COUNTY OF SAN LUIS OBISPO
BOB JONES PATHWAY
(SAN LUIS OBISPO TO ONTARIO ROAD)
FINAL ENVIRONMENTAL IMPACT REPORT

SCH #2010031121

JANUARY 2015

RESPONSE TO COMMENTS

Annotated photos of the DEIR Alignment

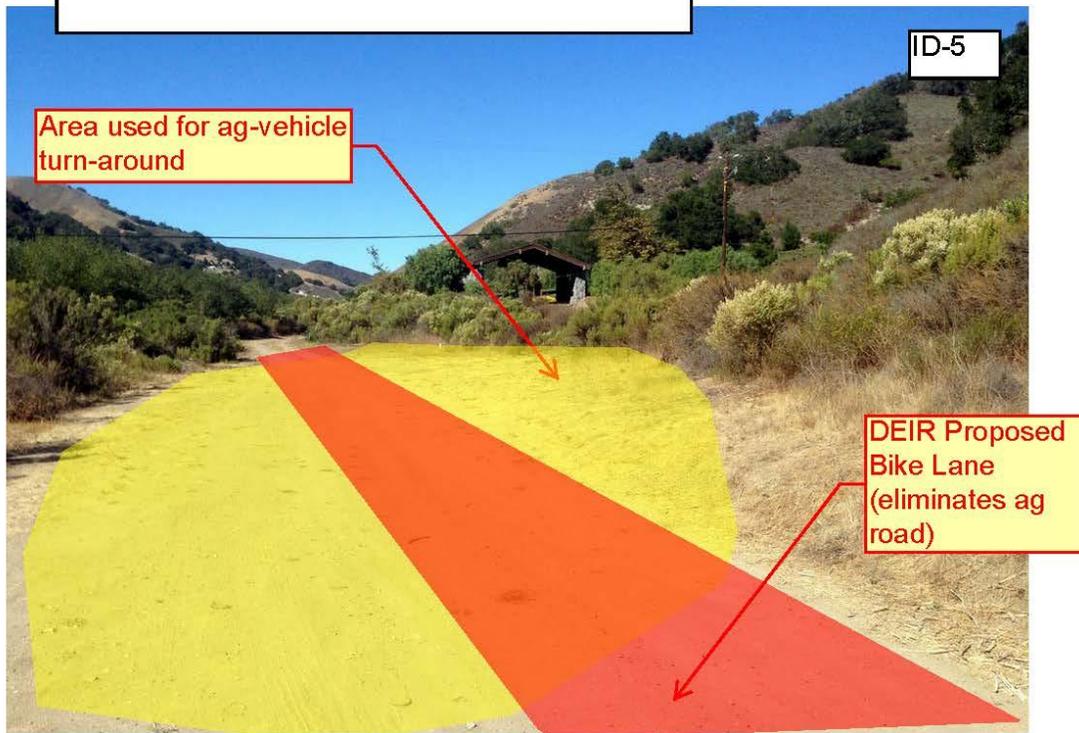
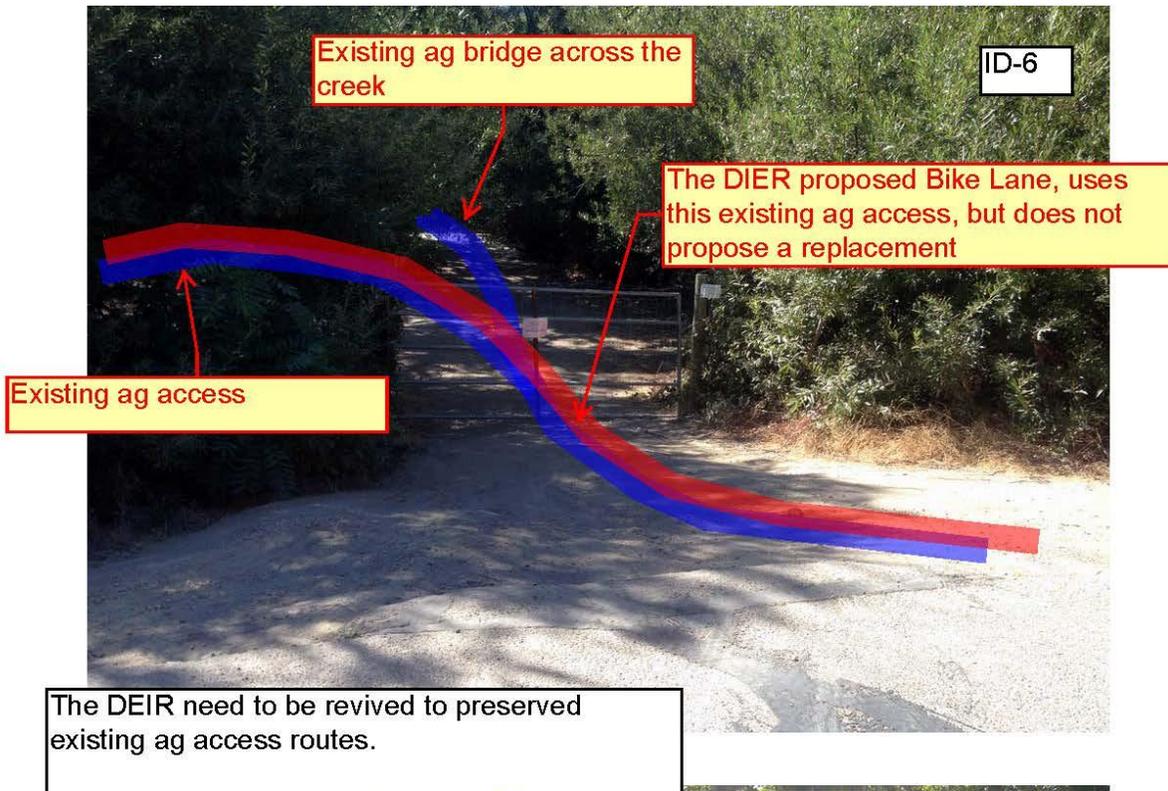
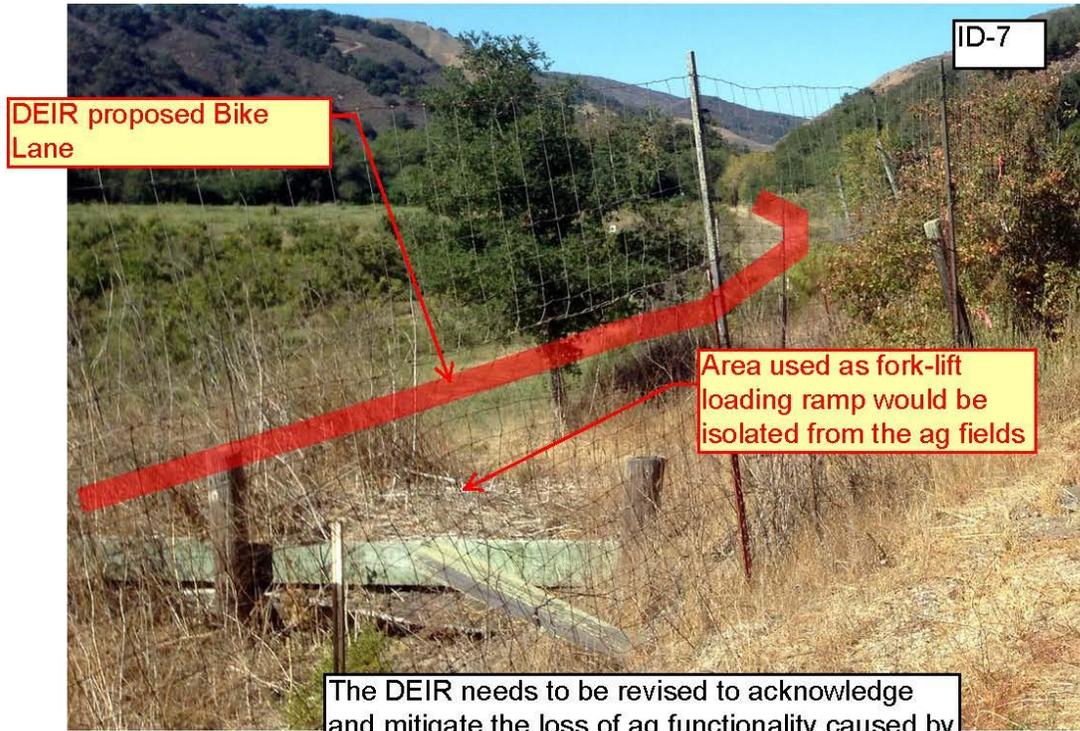
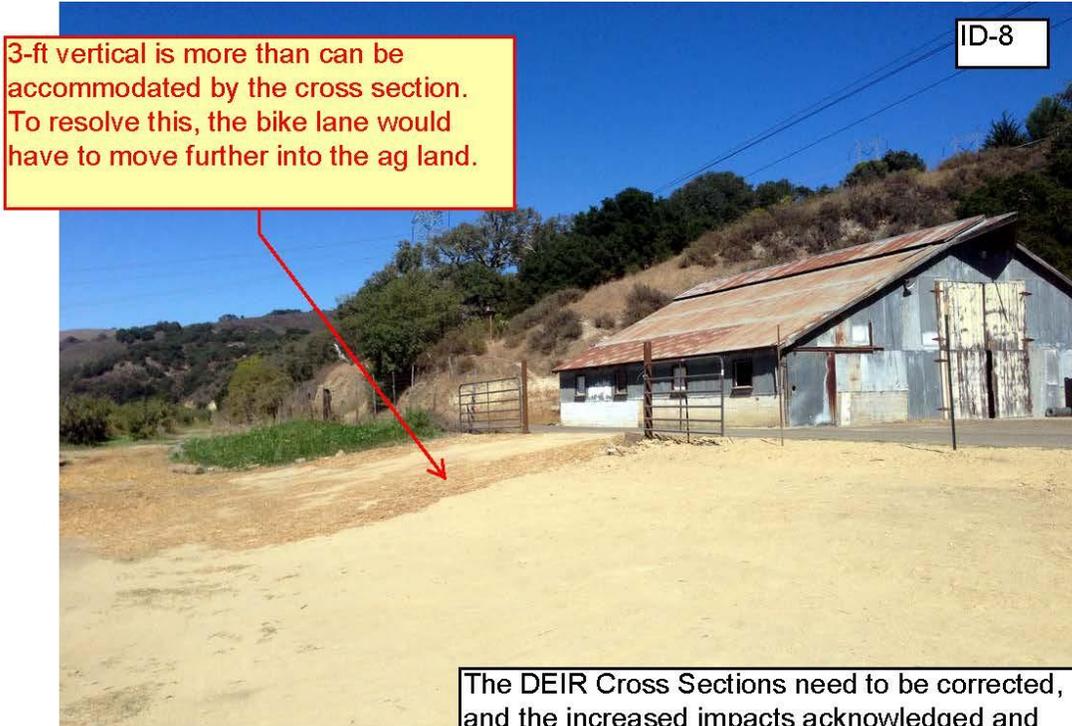
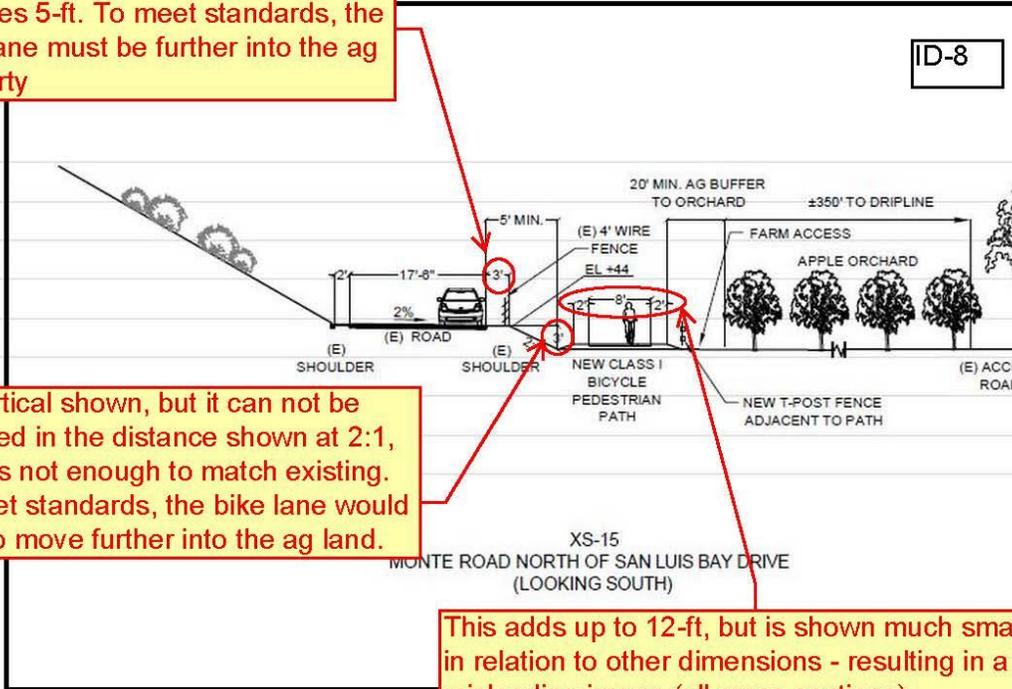
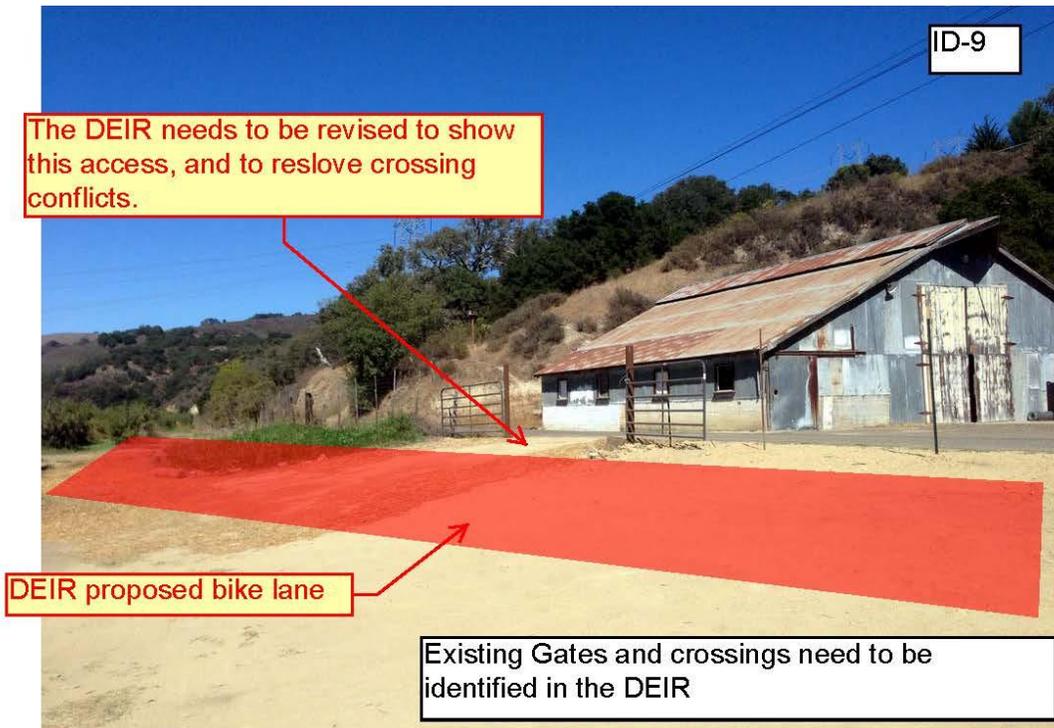
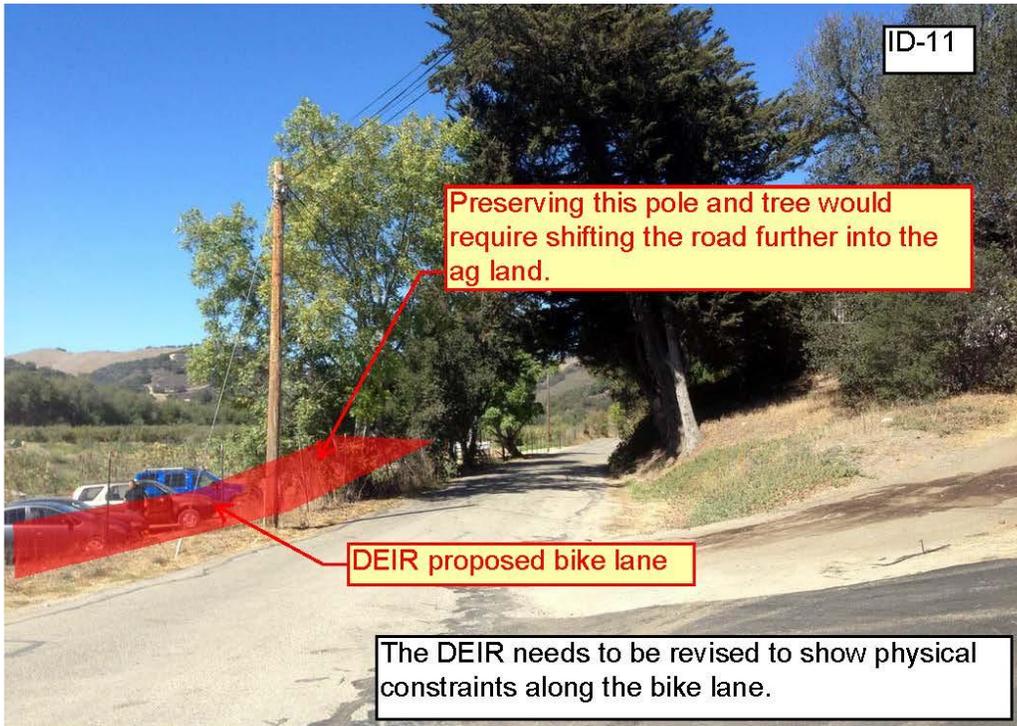
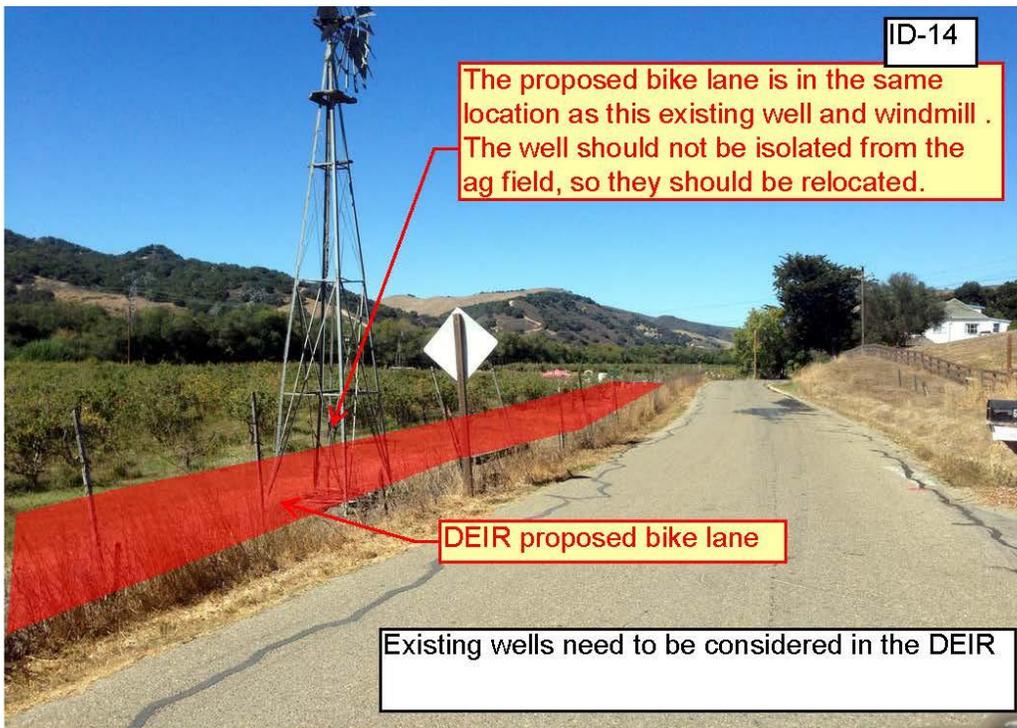
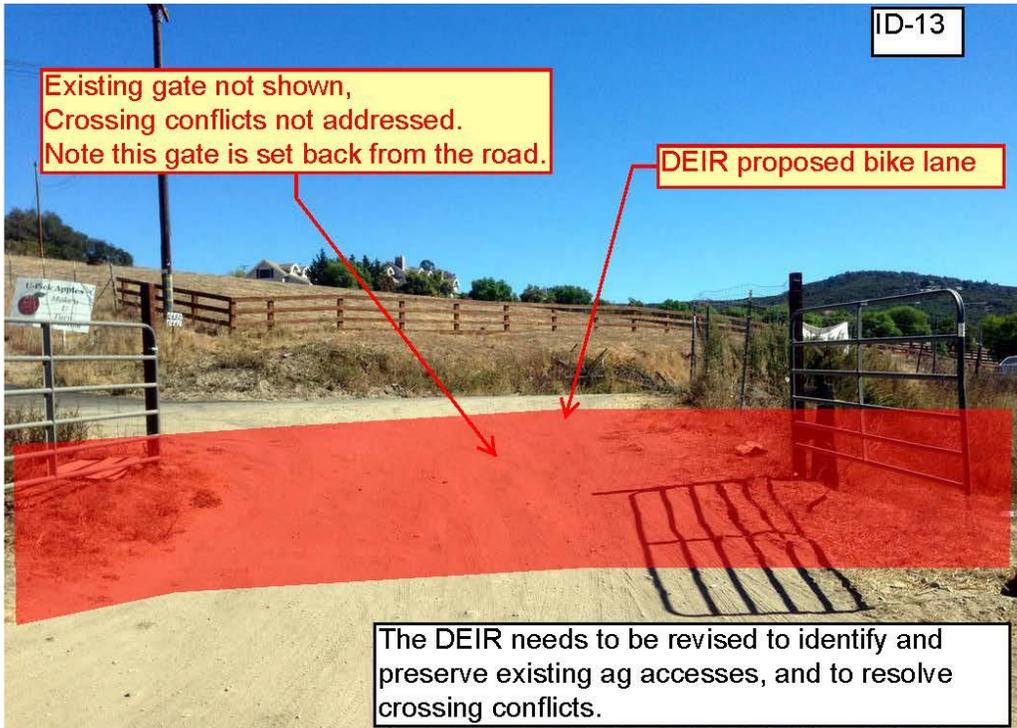
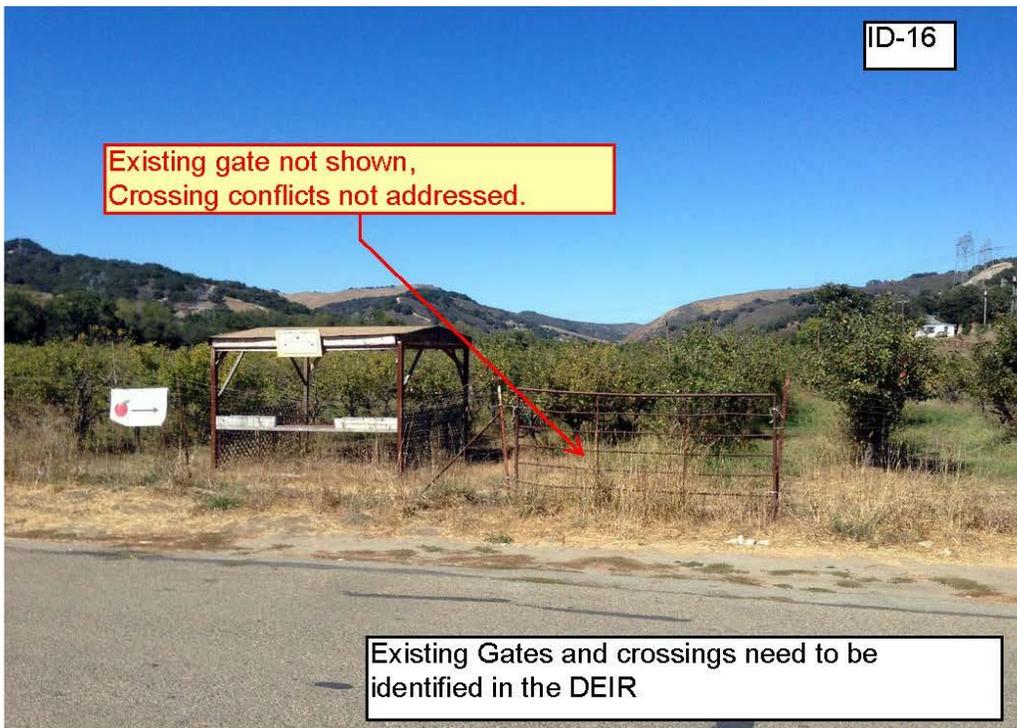
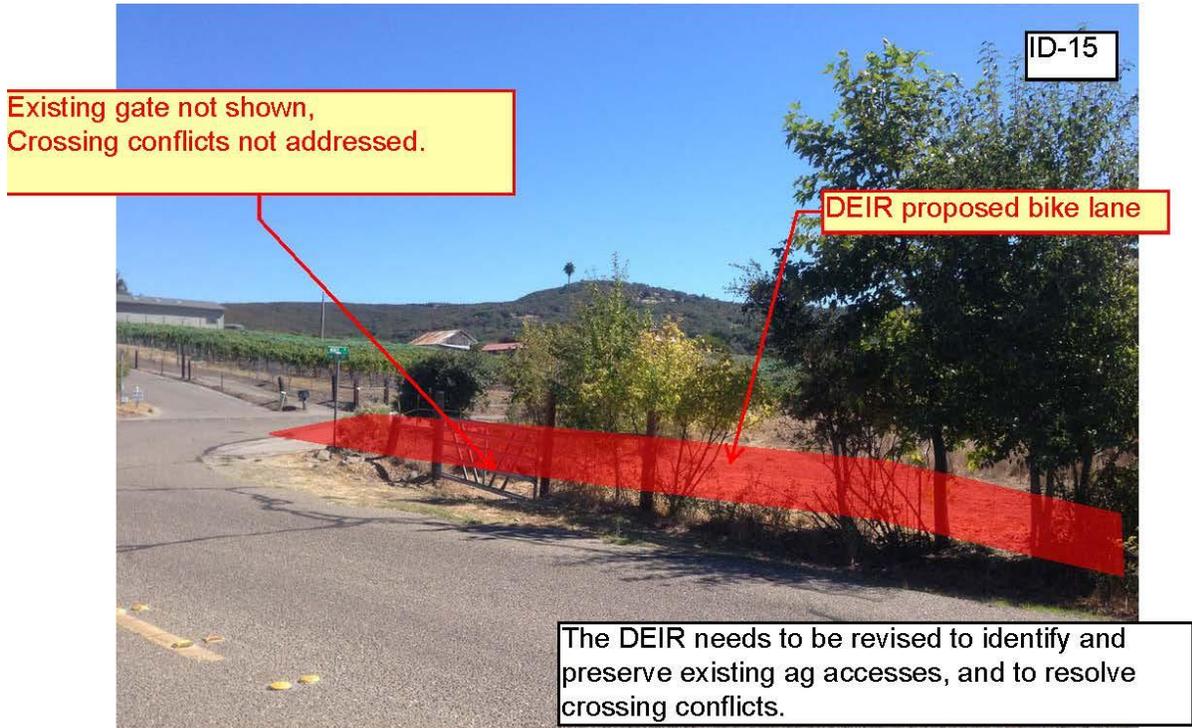
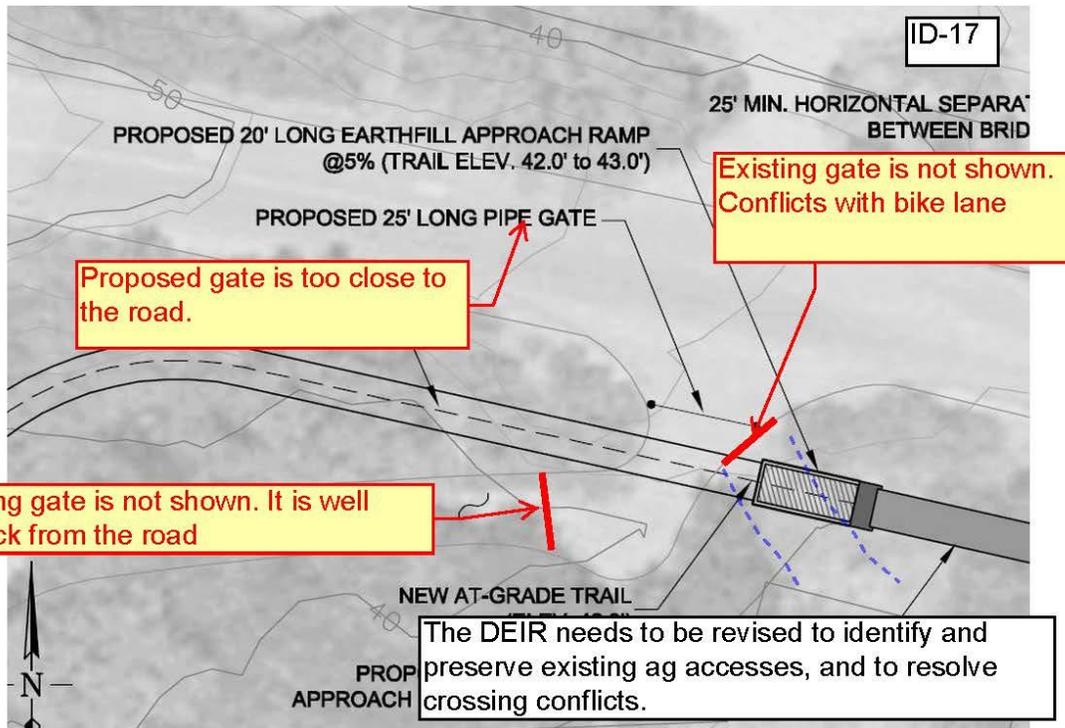
The DEIR needs to be revised to recognize and mitigate the impact of this ag use area.

3-ft vertical is more than can be accommodated by the cross section. To resolve this, the bike lane would have to move further into the ag land.

The DEIR Cross Sections need to be corrected, and the increased impacts acknowledged and mitigated

3-ft shown, but SLO Co std A1-b requires 5-ft. To meet standards, the bike lane must be further into the ag property

3-ft vertical shown, but it can not be achieved in the distance shown at 2:1, and it is not enough to match existing. To meet standards, the bike lane would have to move further into the ag land.

This adds up to 12-ft, but is shown much smaller in relation to other dimensions - resulting in a misleading image (all cross sections)

See Master Response 1. The RDEIR provides an analysis of Alternative 6 (Farming Operations and Conflict Avoidance), which includes an alternative alignment that would avoid Monte Road and the adjacent farming operations, thereby avoiding potential conflicts with these uses. Alternative 6 has been identified as the environmentally superior alternative. Alternative 6 incorporates several alignment and design concepts as suggested in the Farm-Friendly Alternative.
